**Safety Recall: 2018–22 Odyssey SRS Software Update****APPLIES TO**

Year	Model	Trim Level	VIN Range
2018–22	Odyssey	ALL	Check the iN VIN status for eligibility.

The Supplemental Restraint System (SRS) ECU contains incorrect deployment parameters for the side and side curtain airbags, which may cause unintended deployment when the vehicle encounters strong road impacts, such as driving over potholes, speed bumps, or road debris. An unintended airbag deployment could increase the risk of injury.

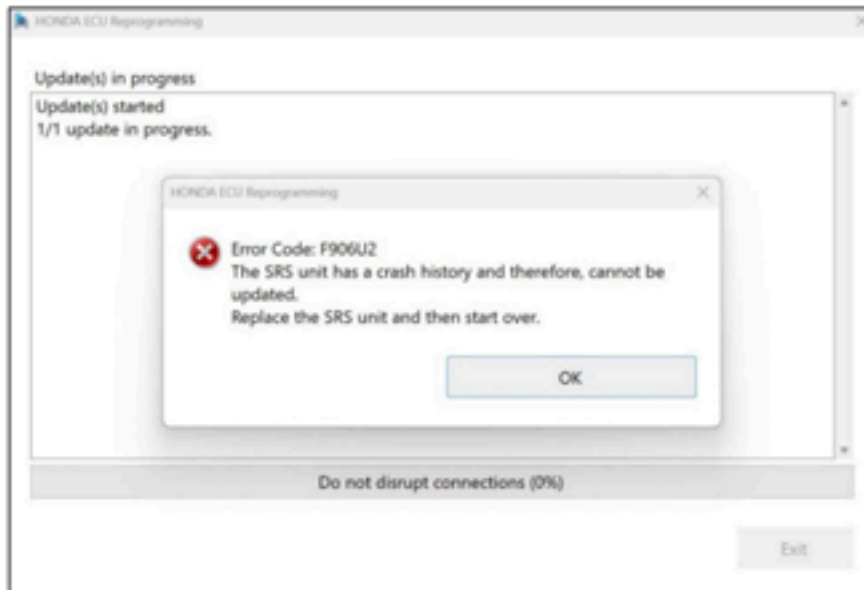
Do the Program IDs for the SRS Control Unit match?

**YES** – No update needed.

**NO** – Proceed to **REPAIR PROCEDURE A**.
